Ref: Proposed Landfill at North LUSK CO. DUBLIN.
(FINGAL LANDFILL)

I wish to object to this proposed
Landfill on Environmental, safety and Health
issues. I am also asking to make a
presentation to E.P.A. We have made
models and we will have more reports
(based on new Information) available shortly.
Please send receipt that you have received Documentation.

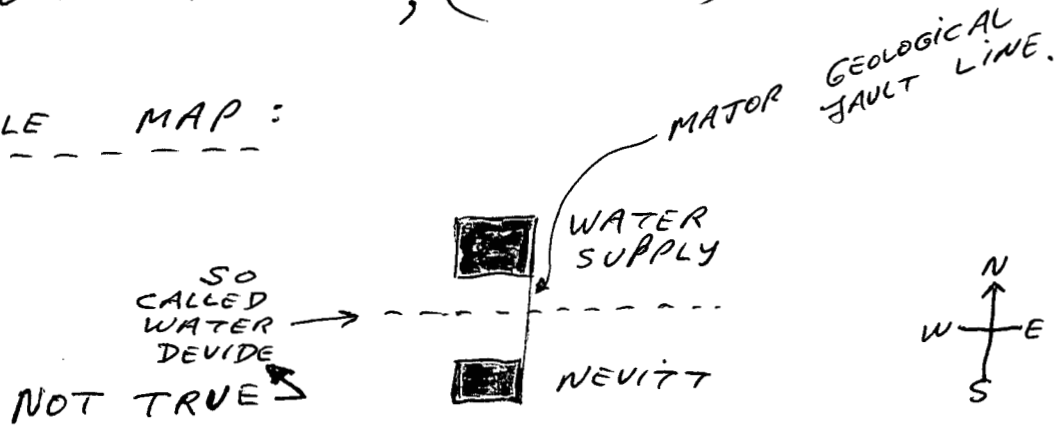
POINT 1 : Fingal County Council is proposing a water divide between the bog of the ring water supply and the Nevitt, (NOT TRUE).

SIMPLE MAP :

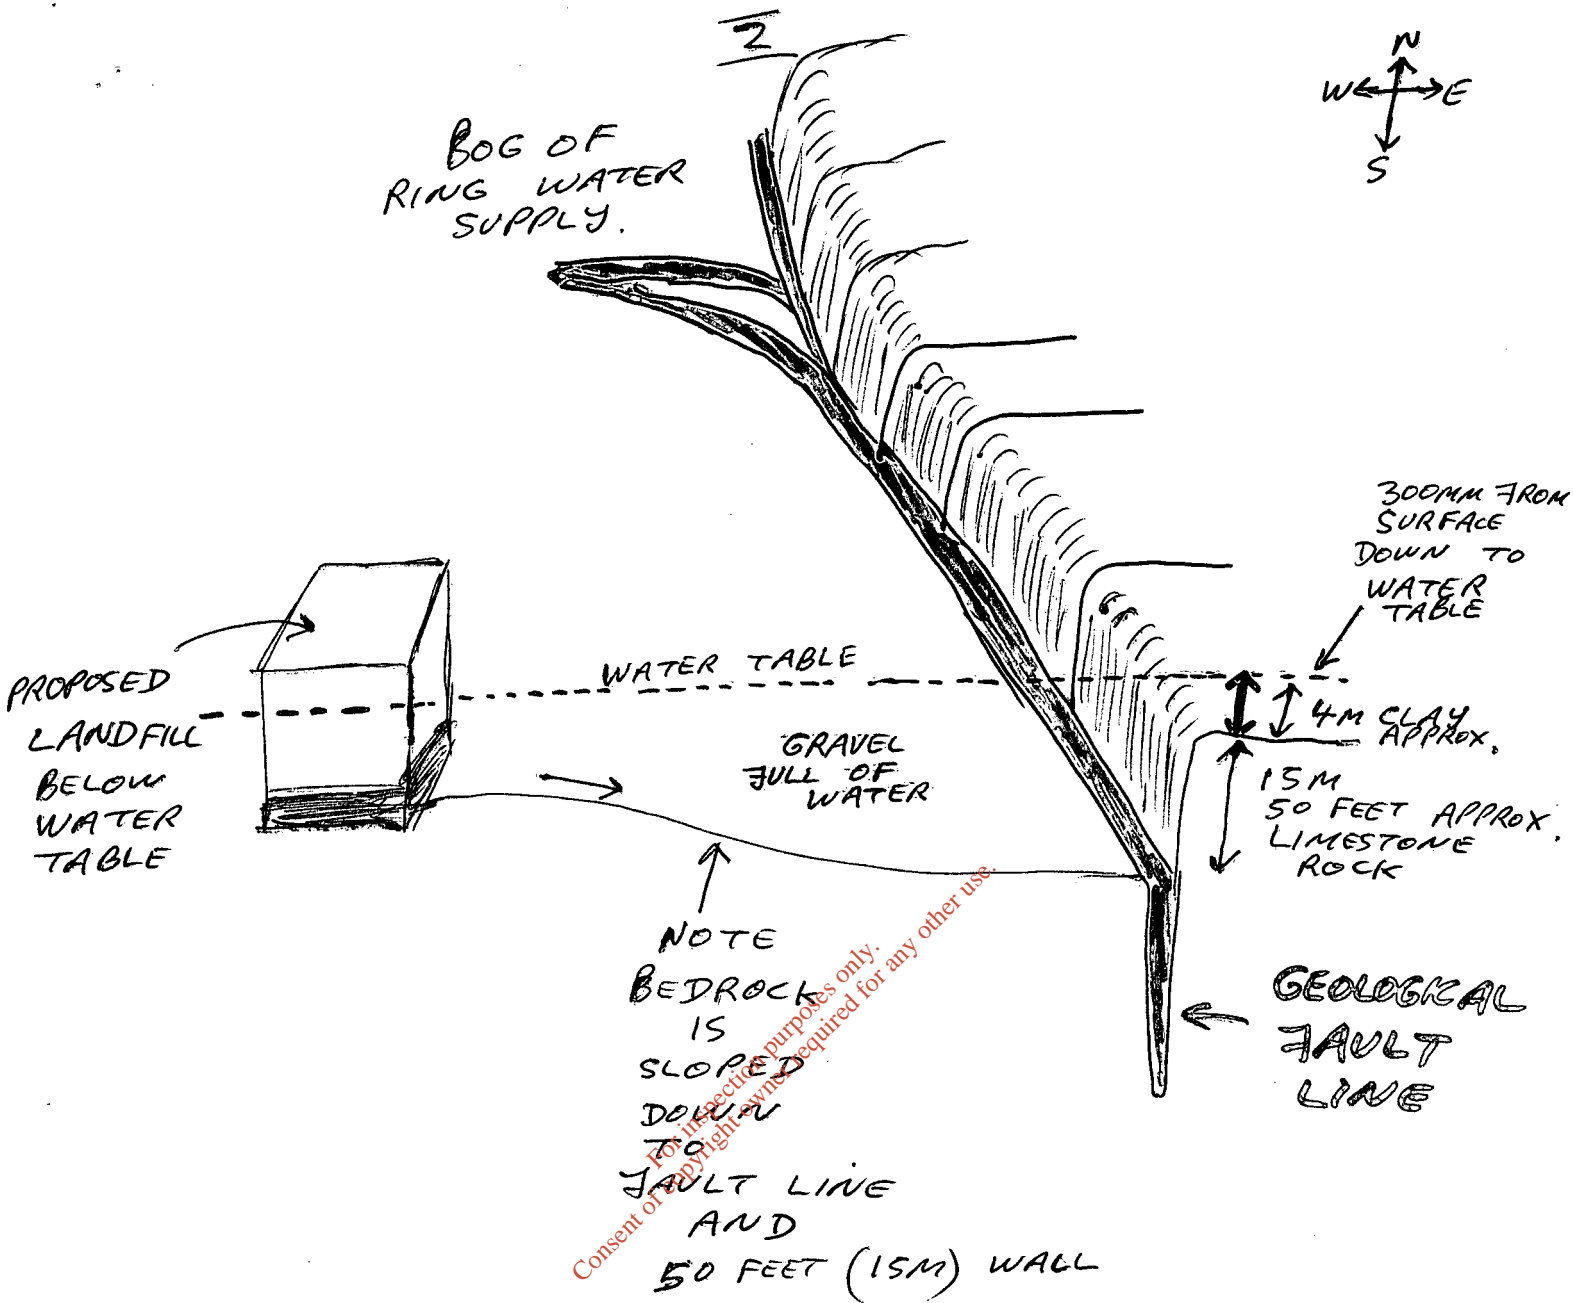
THE COUNCIL FORGOT TO MENTION THE VALLEY BETWEEN the Nevitt and the only water supply in Fingal. They also forgot to mention a major geological fault line joining the Nevitt to the water supply. They also forgot to mention that the eastern side of the fault line is higher creating a wall 50ft, (15.2 M APPROX.), see drawing.

NOTE : BECAUSE LAND FILL IS IN DIRECT CONTACT WITH GROUND WATER , IT CONTRAVENE'S THE E.U. GROUND WATER DIRECTIVE .

SHAPE OF LANDFILL

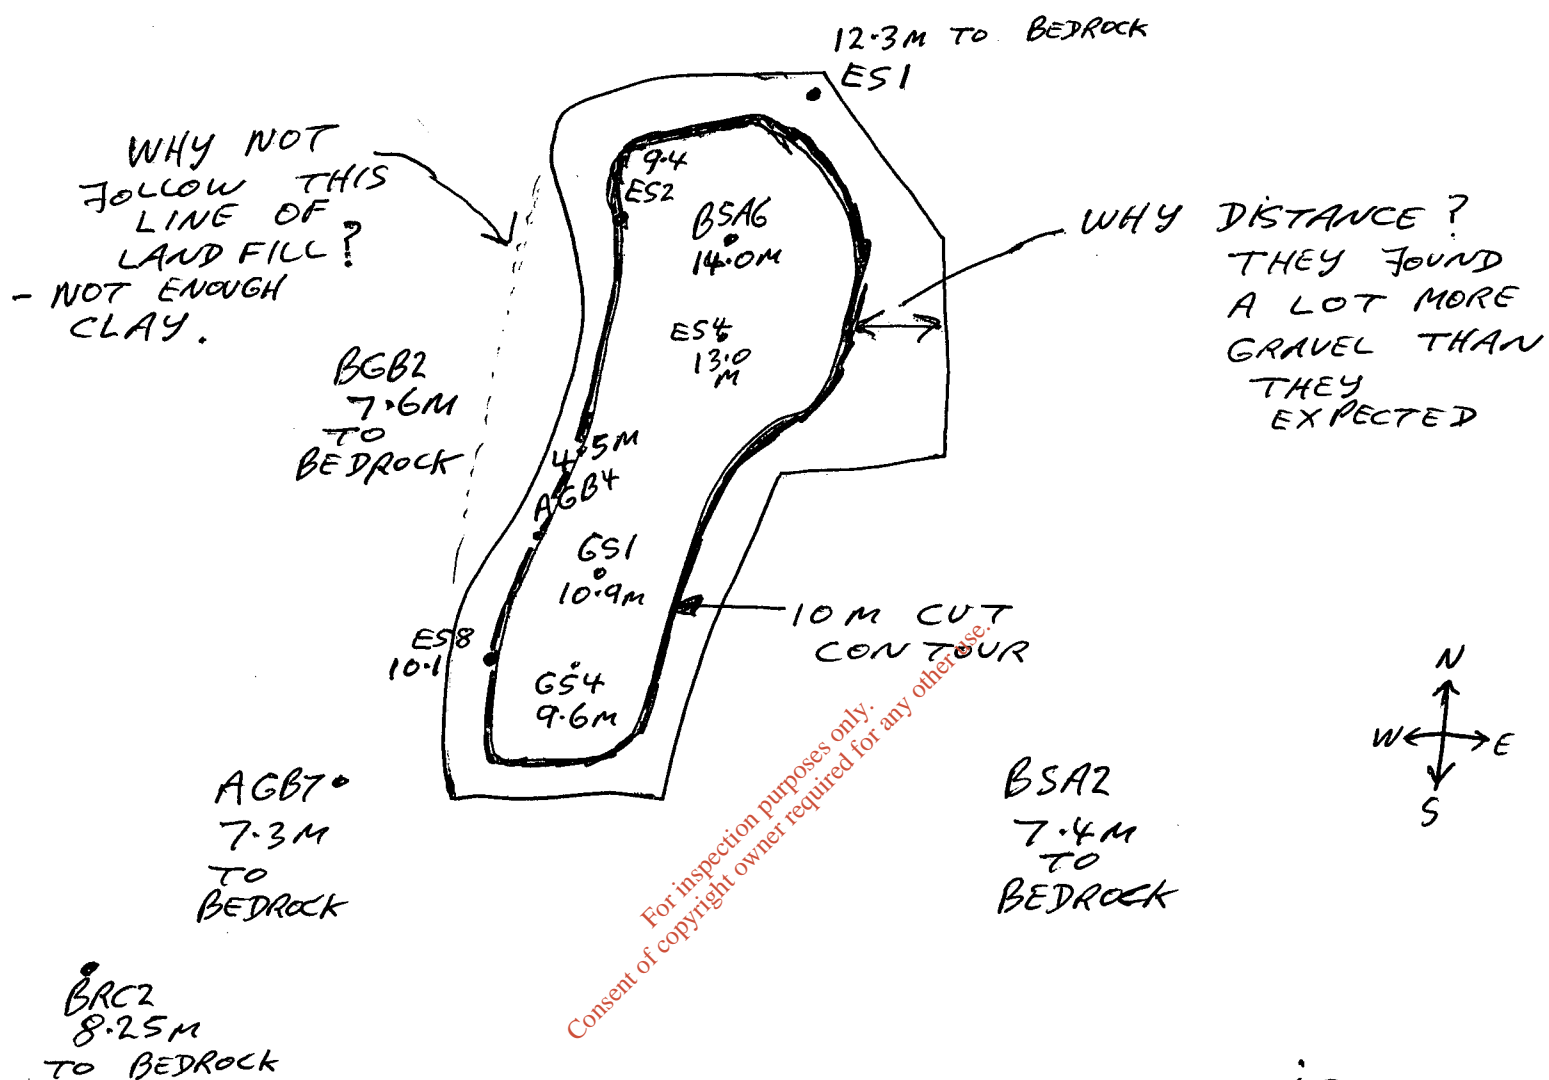
THESE MEASUREMENTS IS THE AMOUNT OF CLAY PRESENT. AS YOU CAN SEE EVEN INSIDE THE 10 M CUT CONTOUR, THERE IS NOT ENOUGH CLAY. They are proposing to dig down 10m and leave 10m underneath landfill i.e. **20M** OF CLAY required inside 10M CUT CONTOUR.

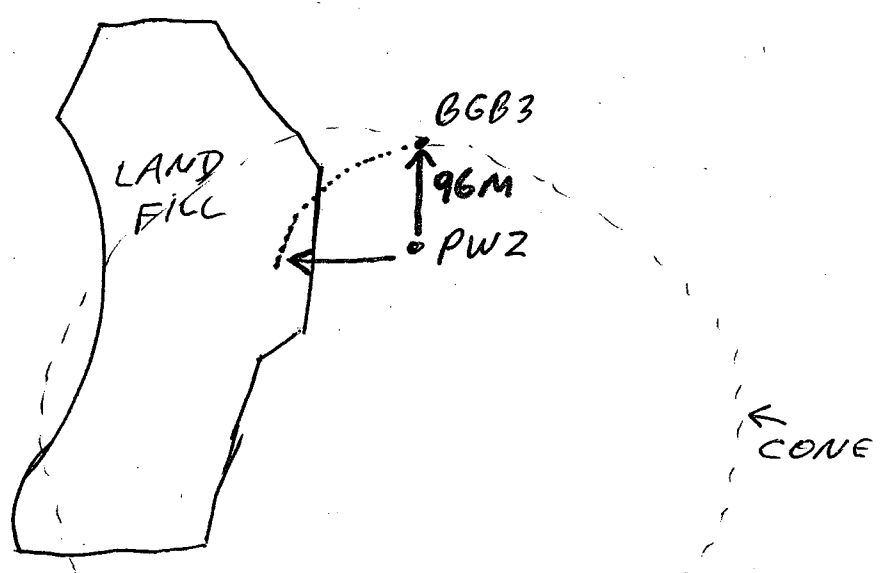
During the pump tests, it was found, all the site of the Revitt is connected. For example

An instantaneous response in BGB3 a 96m north, the water level fell by a maximum of 1.65m during pumping (PW2) and recovery started immediately after the pump was switched off.

There use to be a gravel quarry in the Revitt and the council is surprised to find so much gravel.

We asked for Dye test to be carried out they said it would take 100 years for leachate to travel through the gravelly clay. How wrong they are.
